**STAFF REPORT  
FOR THE HISTORIC REVIEW BOARD**

**FILE NUMBER:** DR-10-12

**REQUEST:** New Home Construction

**SITE LOCATION:** 1689 6<sup>th</sup> Avenue

**1 GARAGE FLOOR PLAN**  
S2  
1/4" = 1'-0"

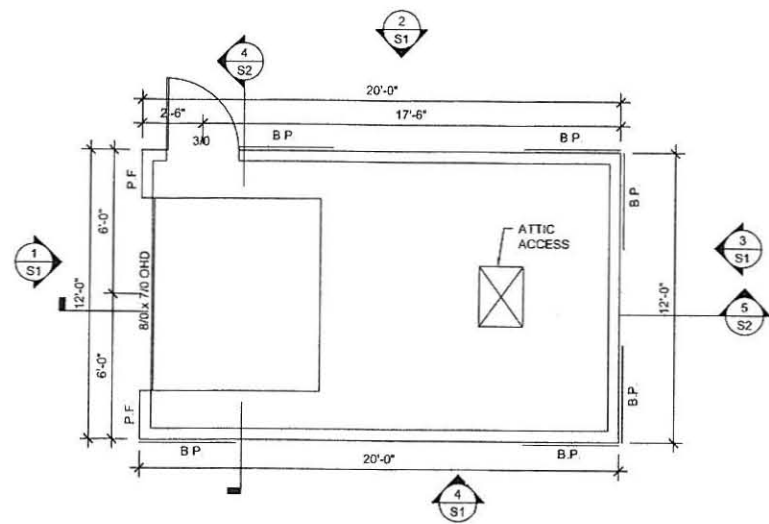
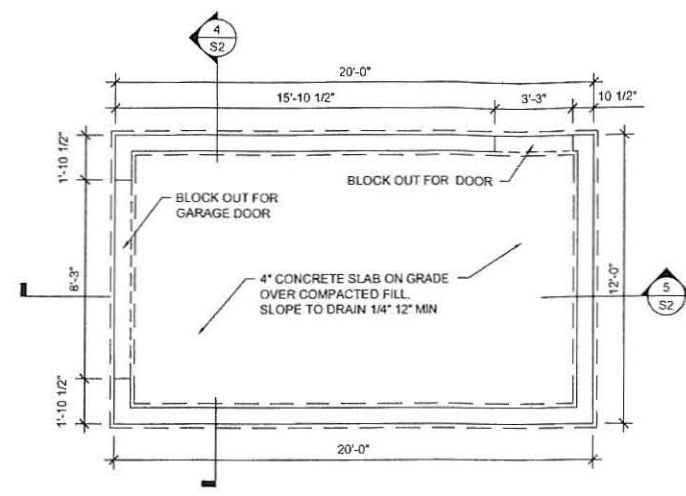
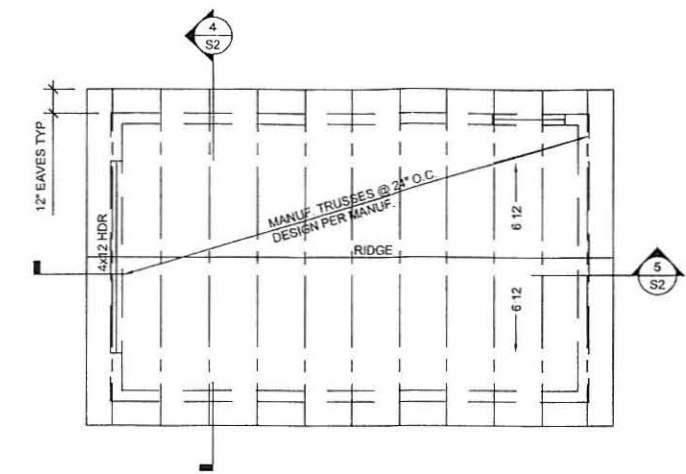
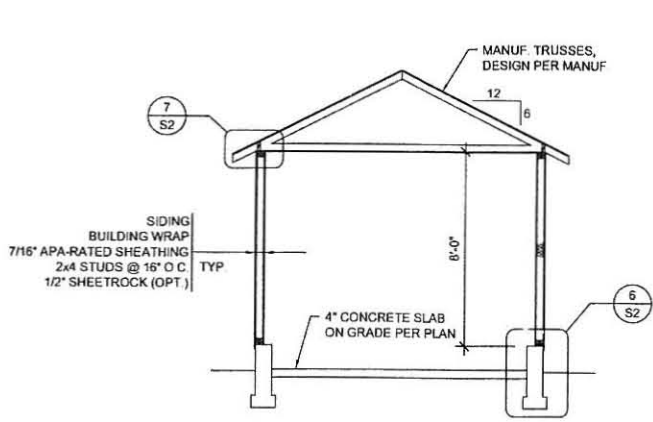
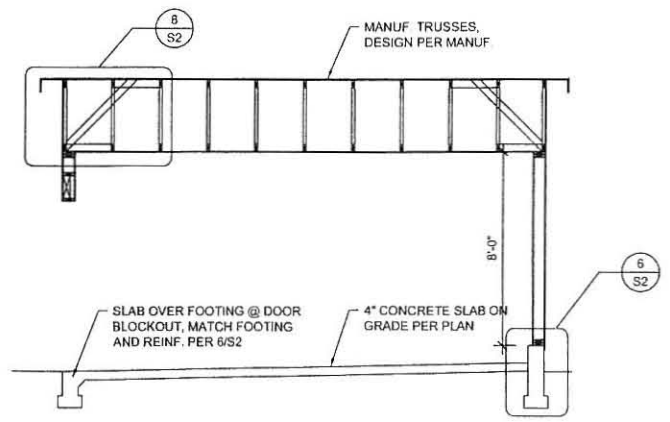
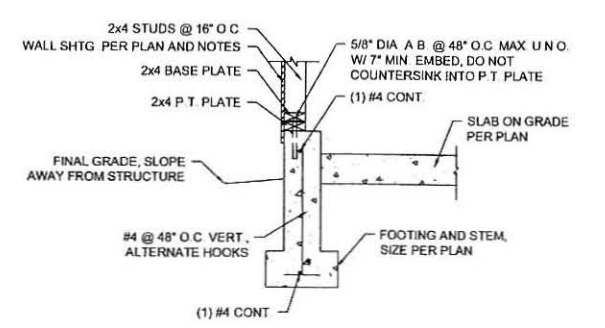
**FINDING NO. 3:** The proposed garage would be accessed from the alley. The applicant is proposing a 6:12 roof pitch, which is less than that of the house. The garage has a 1' side yard setback and a 3' rear yard setback. The applicant has not specified the siding material. Condition of Approval #9

8. Foundation and basements. The windows in the wells shall be wood windows.
9. Garage.
  - a. With the exception of modifications required by these conditions, the garage shall conform to the drawings labeled S1-S2, dated 3/13/2011.

- b. The garage shall have wood siding that is the same material as the siding on the house.

**1 NORTH ELEVATION**  
D1  
1/4" = 1'-0"

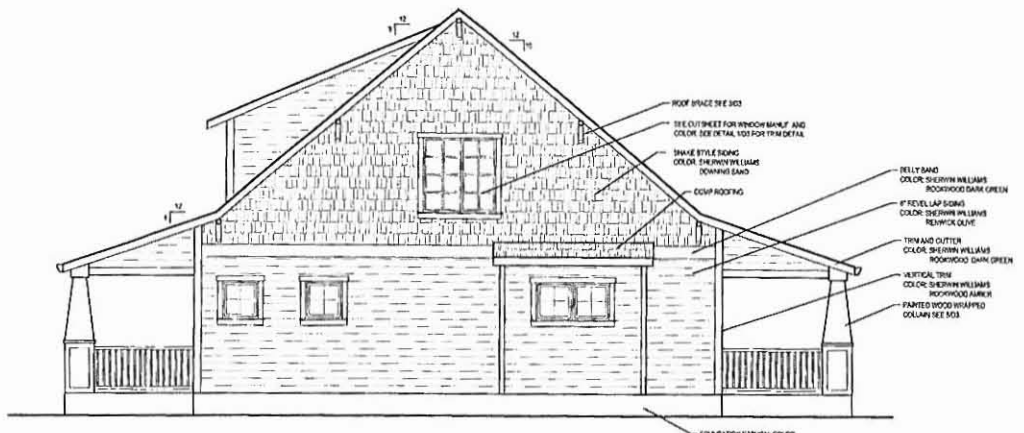
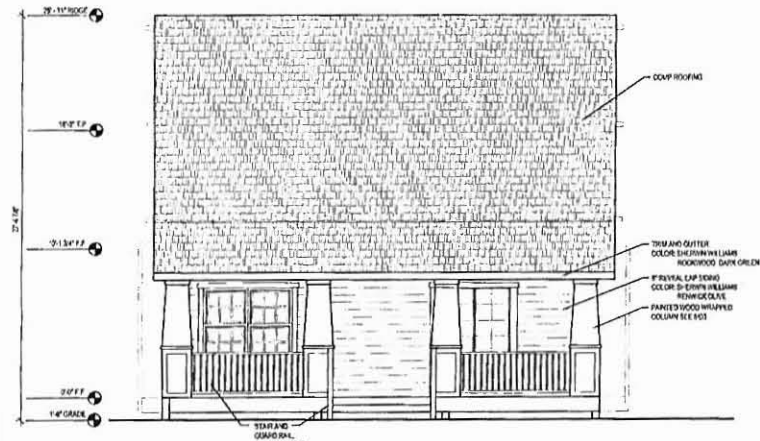
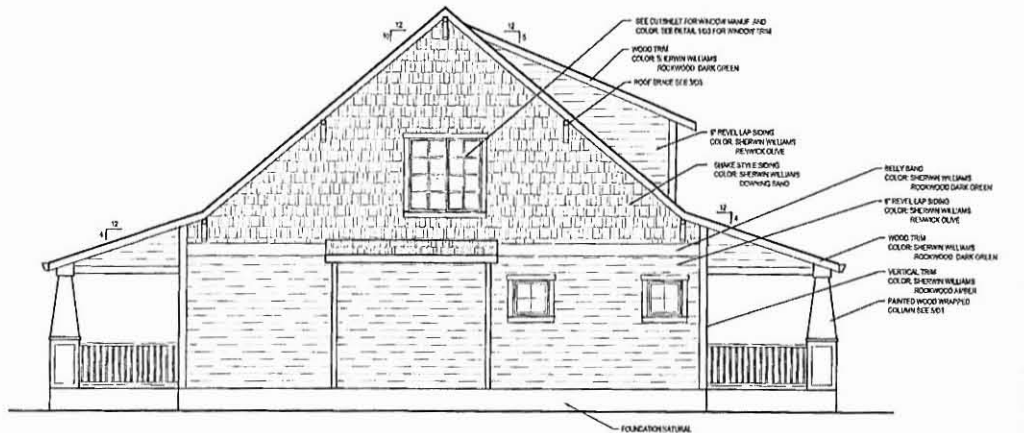
**FINDING NO. 7:** The applicant proposes 1/1 light windows on the front and rear elevations. The front elevation has two sets of paired 1/1 light windows on the first floor and a single 1/1 light window in the second floor shed dormer. The rear elevation has a set of paired 1/1 light windows. The cut sheet submitted is for a Prairie style 9 light window. If this is chosen, it would be compatible if it had simulated or true divided lights rather than the internal grilles. The side elevations have a single casement window. Paired 1/1 light windows would be more compatible with the generally Craftsman architectural features of the structure. A previous version of the plans, also dated 4/22/11 (see Exhibit HRB-4) showed each window with 8 lights, which would also be more appropriate, provided that they were simulated or true divided lights. Casement windows with multiple simulated or true divided lights would also be appropriate. Four windows on the west elevation and two windows on the east elevation are shown as single light windows. A previous version of the plans showed these with 4 lights, which would also be appropriate. The criteria are met upon the fulfillment of Condition of Approval #5, which requires the front and rear windows to be 1/1 or to have simulated or divided lights and any casement windows to have simulated or divided lights.

**FINDING NO. 9:** Sheet D 1 in Exhibit HRB-3 calls for 6" reveal lap siding. A cut sheet was submitted for wood shiplap siding. Lap siding is appropriate for the area, however shiplap or channel siding is typically on Queen Anne style residences rather than on houses that have a Craftsman influence. Condition of Approval #7 requires bevel lap siding for the house.

**FINDING NO. 12:** The applicant is proposing 1.5' of the foundation will be exposed. Window wells are shown on the east and west sides of the house per the floor plans, but are not shown on the elevations. Condition of Approval #8 provides for the material of the windows in the wells to match the material of the windows elsewhere on the house.

4. Lighting. The lighting shall be located on the front porch.
5. Windows.
  - a. The windows shall be wood and 1/1 light or with multiple simulated or true divided lights. The second floor windows on the side facades shall either be:

6. Entryways. The entryways shall either have a door with a single light or a door with multiple simulated or true divided lights.
7. Siding and exterior finish. The siding shall be horizontal bevel lap wood siding on the first floor and wood shingles on the second floor.
